VALUE ENGINEERING WORKSHOP

WIDENING US 441 – FARGO TO PEARSON PROJECTS EDS 441 (41, 46, 48, & 49) Clinch & Atkinson Counties, Georgia

VALUE ENGINEERING TEAM STUDY

PROPOSAL NUMBER:	SB-5.0
PAGE NUMBER:	1 of 5

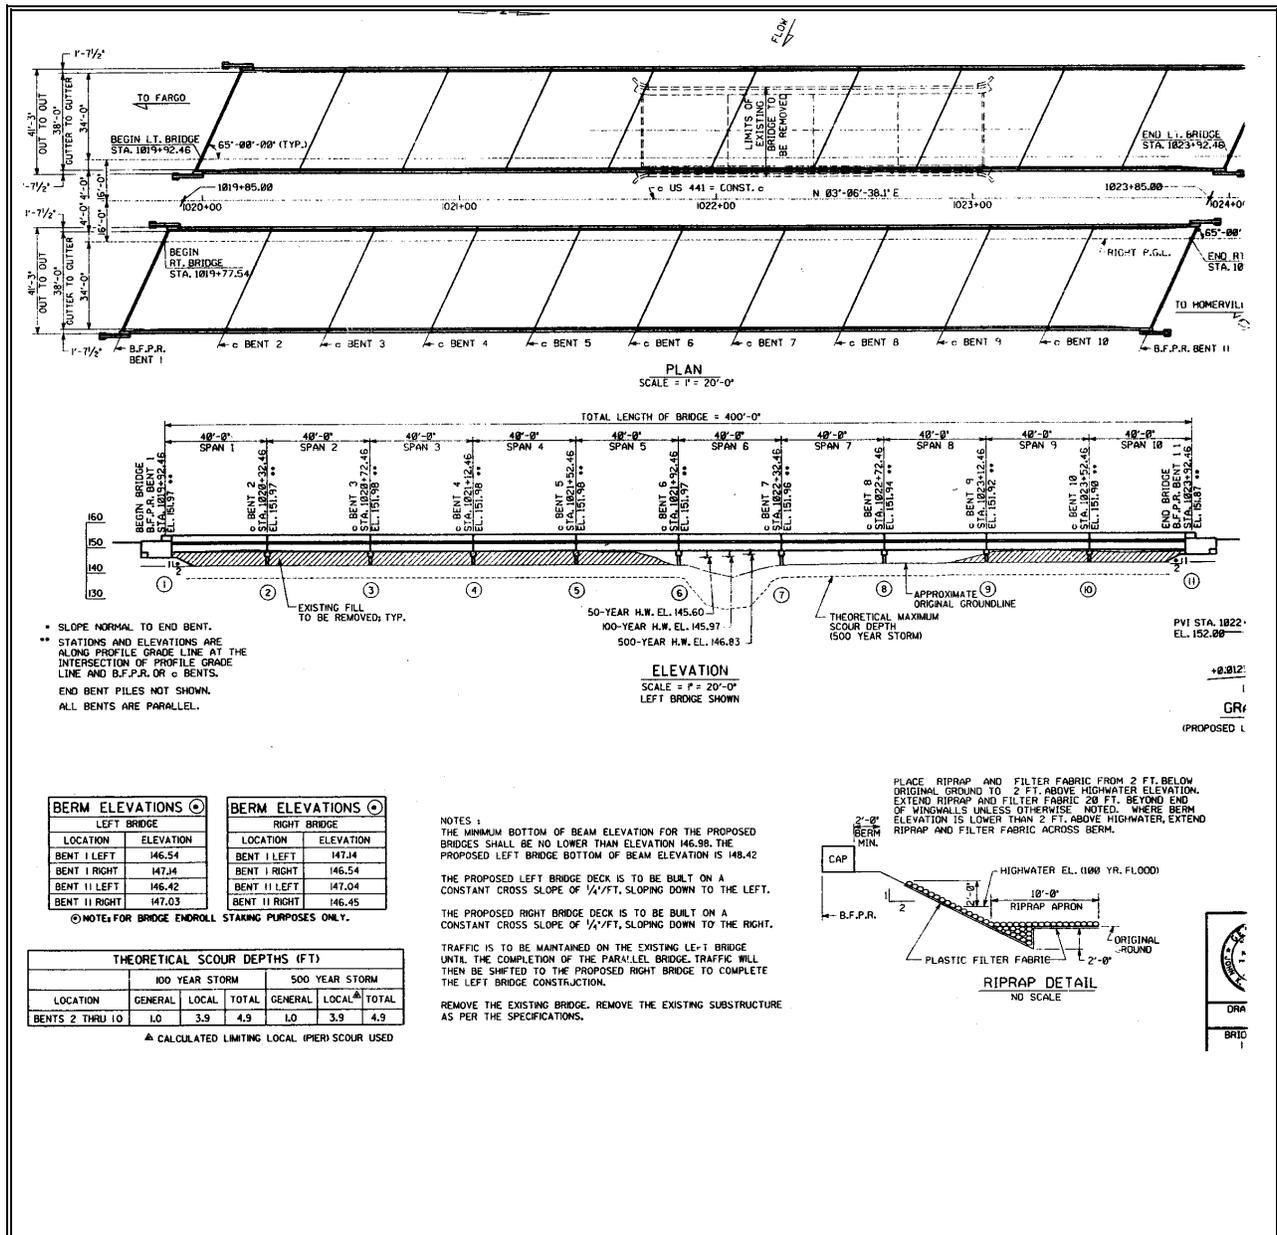
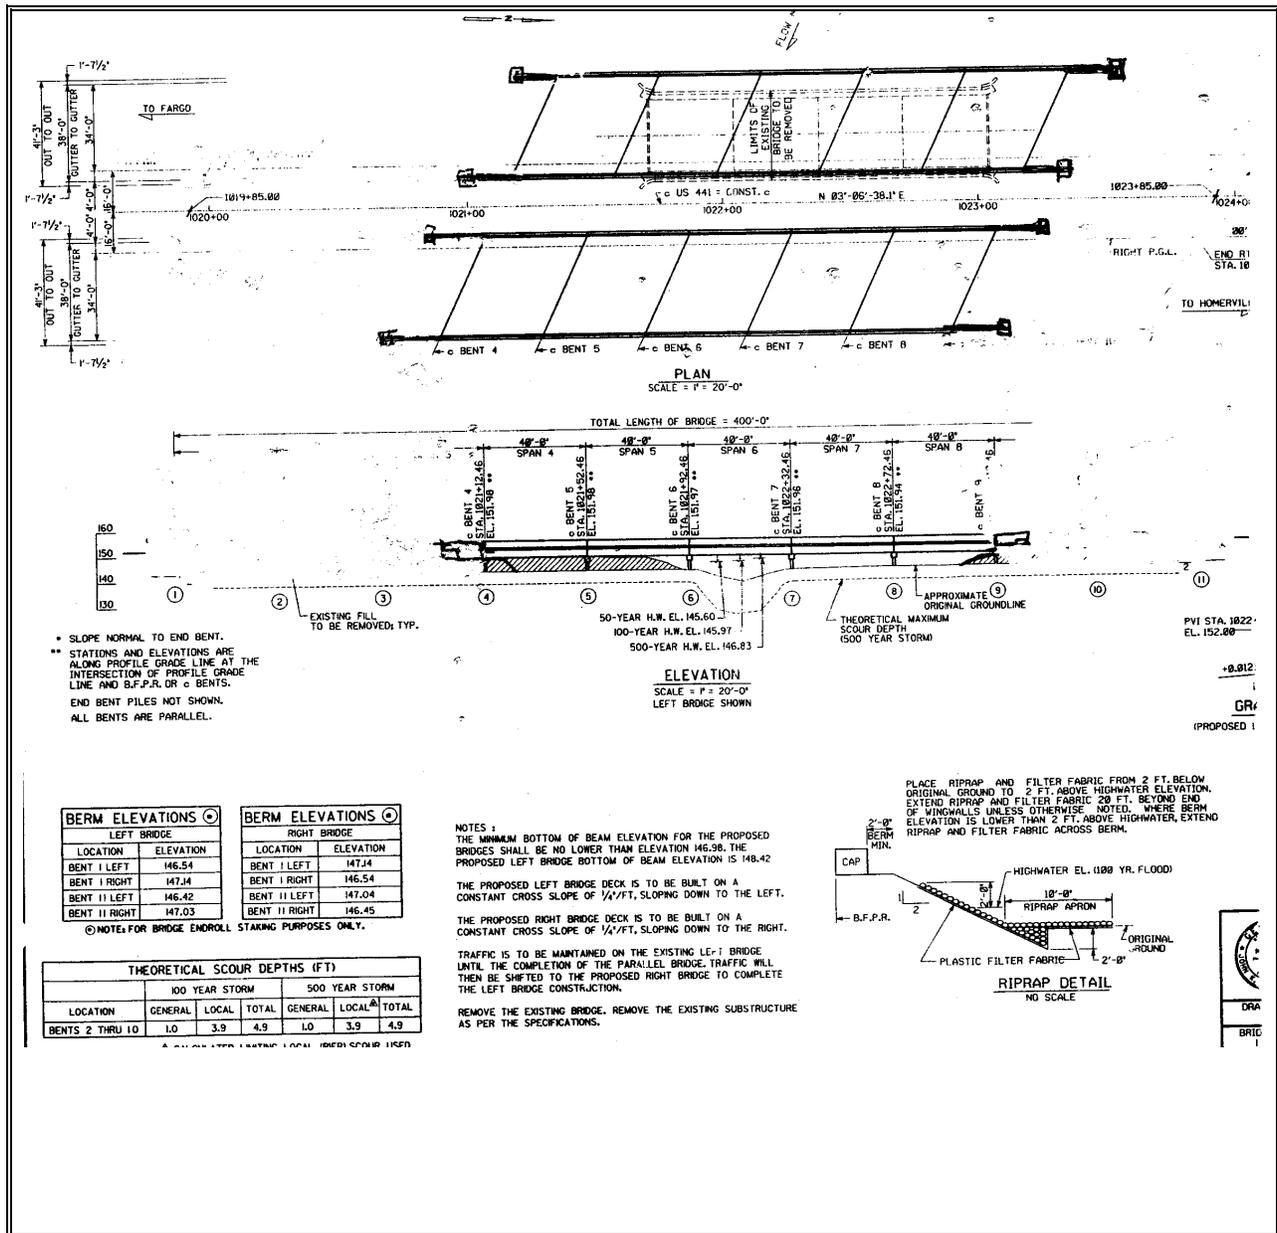
PROPOSED CHANGE: The proposed change recommends eliminating the not needed begin spans 1, 2 & 3 and end spans 9 & 10 as designed on both bridges and shortening the length of the bridges by 200'-0". The new begin bridge station is 1021+05 and the end bridge station is 1023+05.

PROPOSAL NUMBER:	SB-8.0
PAGE NUMBER:	4 of 4

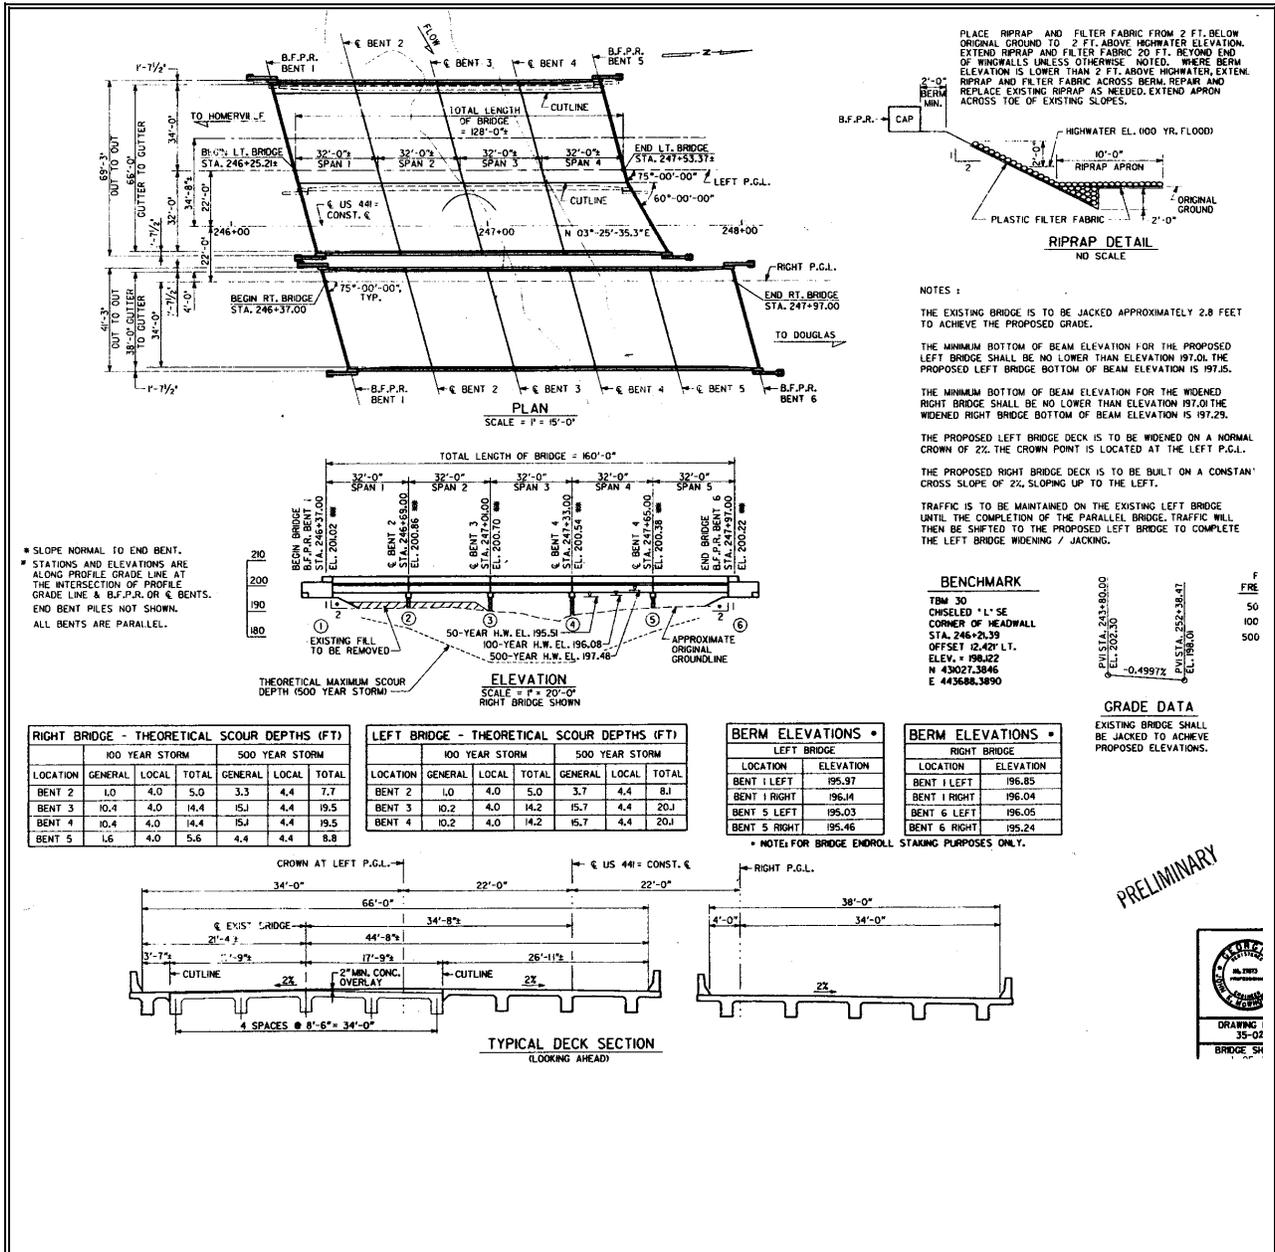
PROPOSED CHANGE: The proposed change recommendation would shorten the deceleration lane enough so that the start of the taper would occur south of the proposed bridge. The proposed bridge would be 41'-3" wide.

PROPOSAL NUMBER: RW-1.0

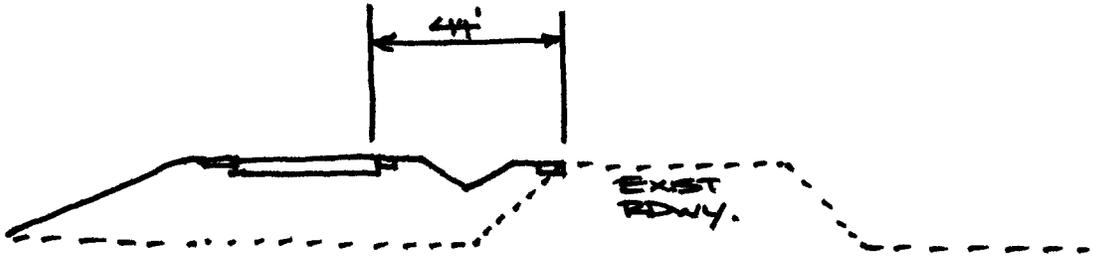
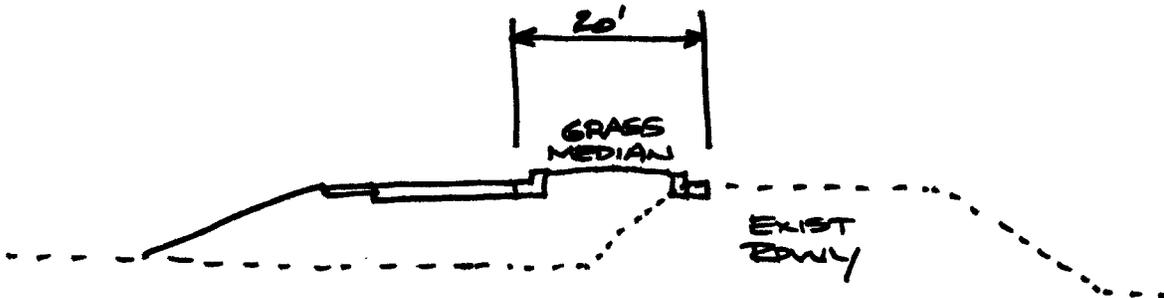
PROPOSAL DESCRIPTION: REVISE TYPICAL ROADWAY SECTION TO A
RURAL ROADWAY SECTION WITH A 20'
RAISED MEDIAN.

PROPOSED CHANGE: The proposed change recommendation would include a rural roadway section with a 20' wide raised median. This median would be a grassed median, with curb and gutter. This section will only replace the rural sections of the current design.

Eliminates most drainage in the median. Drainage on the proposed change will only be needed at the superelevated sections.

The proposed design change would include cost savings, as well as a reduction of ROW and wetland impacts. This outweighs the disadvantages of a lower roadway design speed.

PROPOSAL NUMBER: RW-1.1

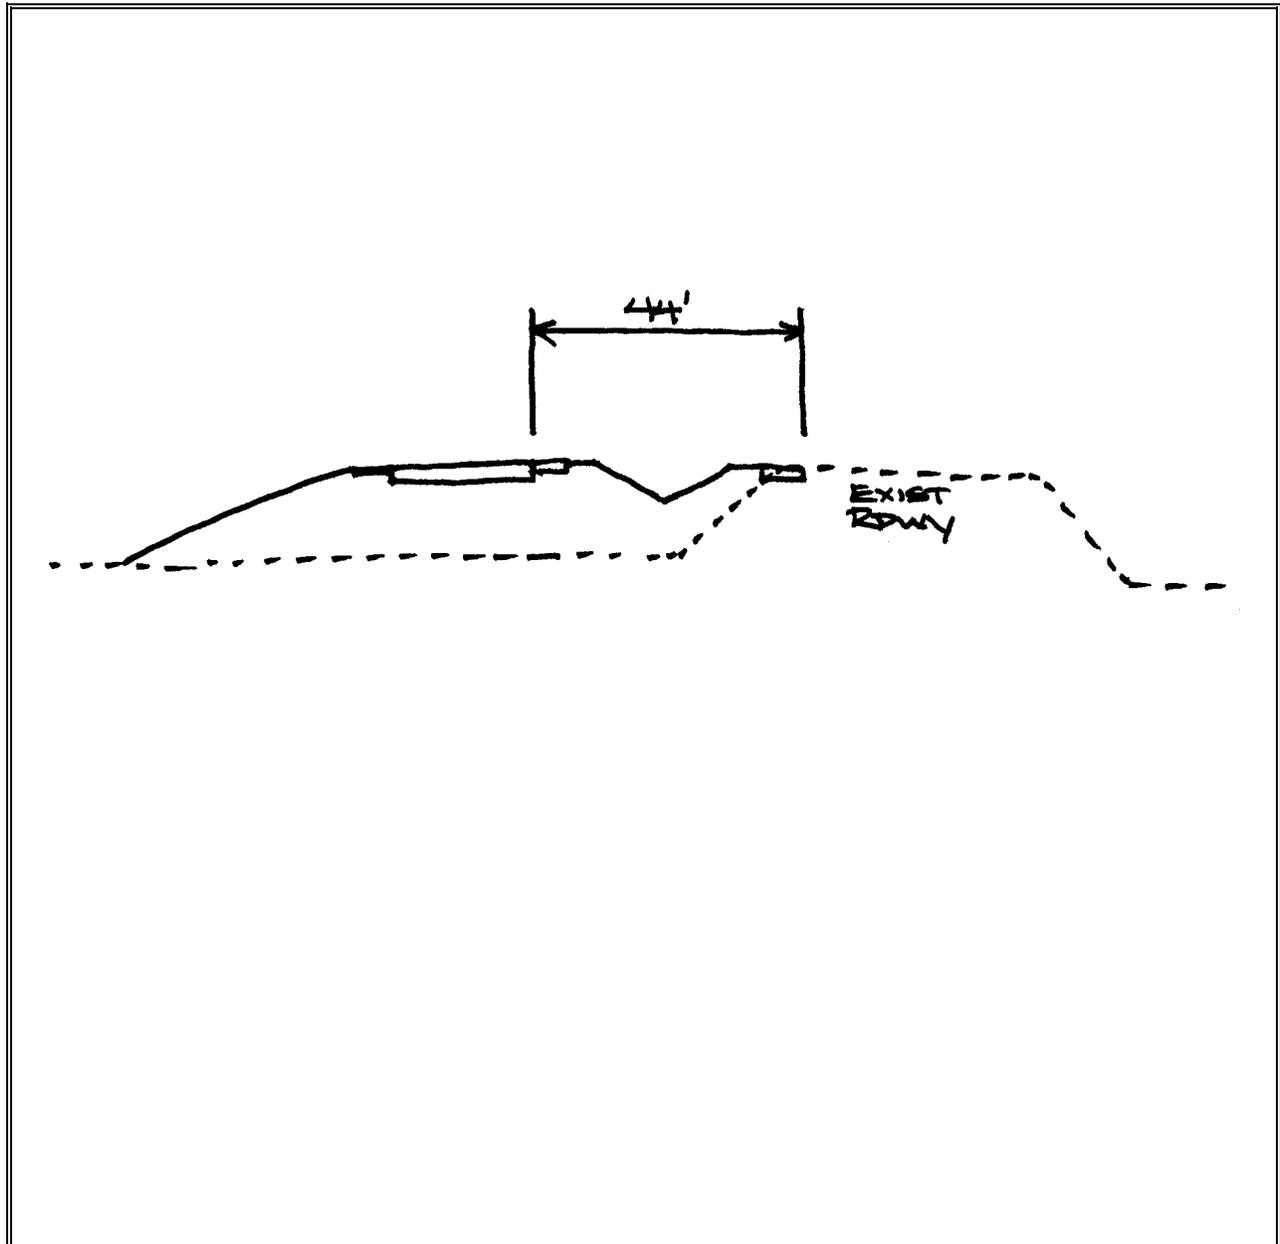
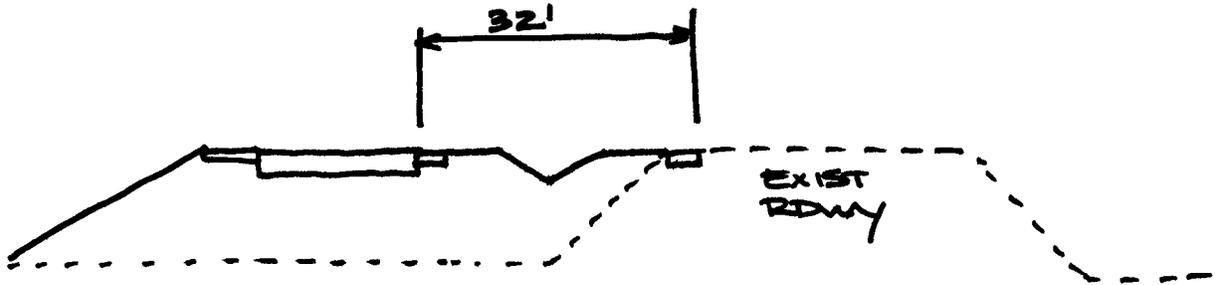
PROPOSED CHANGE: The proposed change recommendation would include a rural typical section with a 32' depressed median.

The proposed design change would include cost savings, as well as a reduction of ROW and wetland impacts. This outweighs the disadvantages of conflicts with current GDOT policy.

PROPOSAL NUMBER:	RW-2.0
PAGE NUMBER:	4 of 6

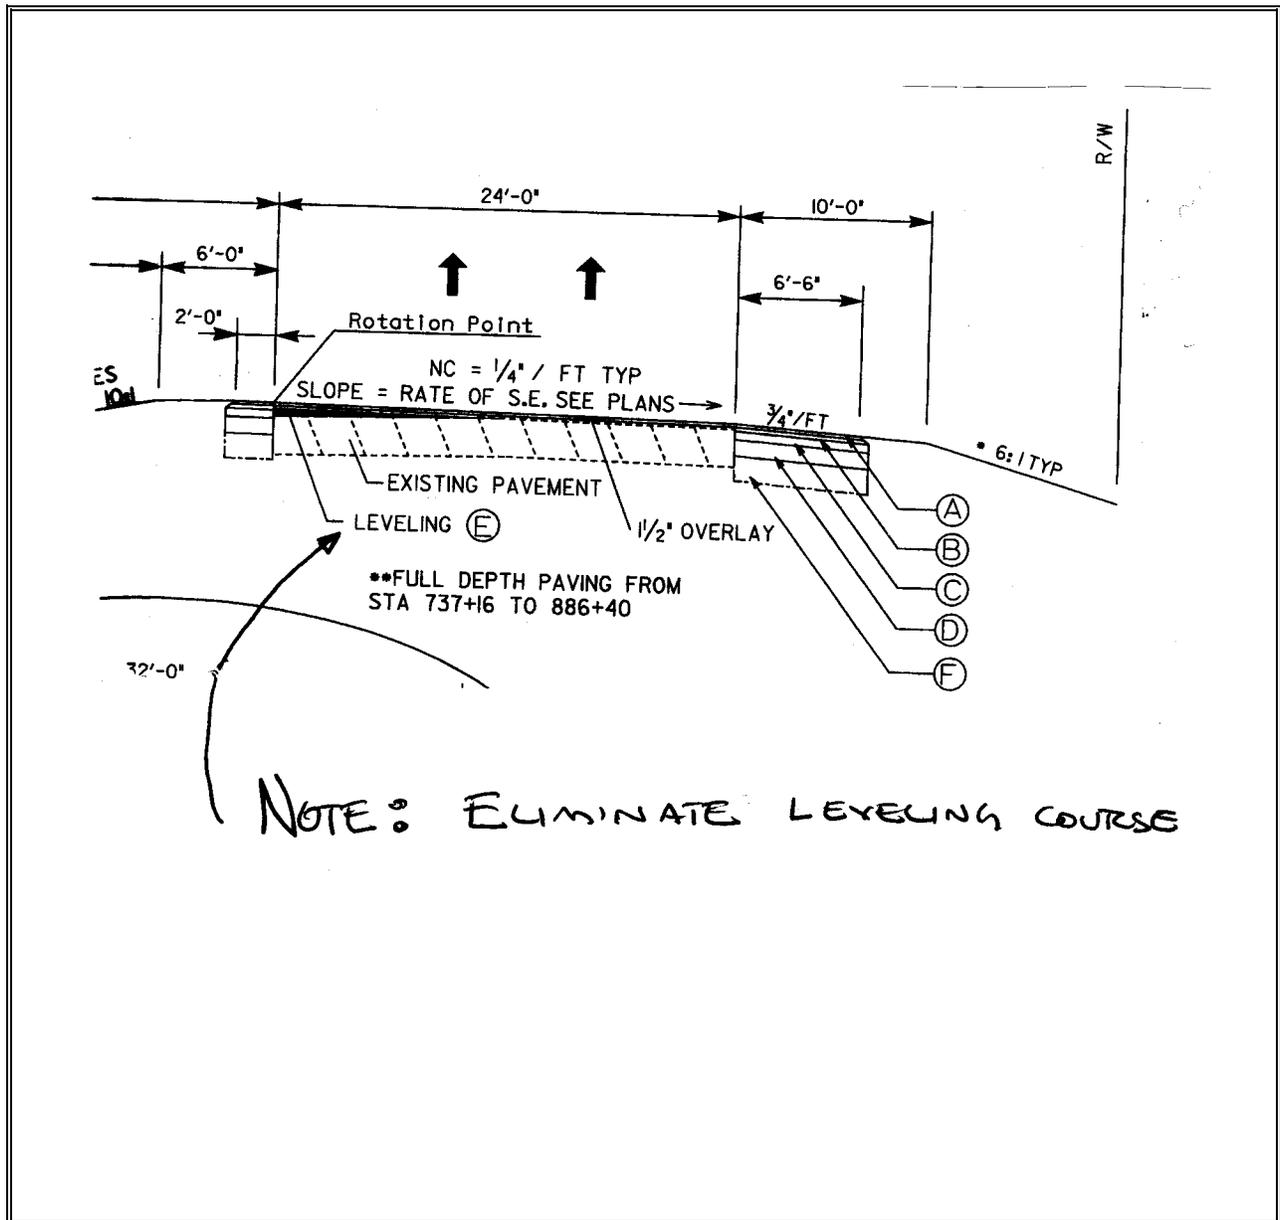
ORIGINAL DESIGN: The original design uses leveling on the existing section to remove the crown that is on the existing roadway centerline.

PROPOSED CHANGE: The proposed change recommendation would leave the existing roadway crowned in lieu of removing the crown with leveling.

Proposed design change would include cost reduction and reduction in construction time. AASHTO, chapter 7, Cross Slope, states “Each roadway of a divided arterial may be sloped to drain to both edges, or each roadway may be sloped to drain to its outer edge”
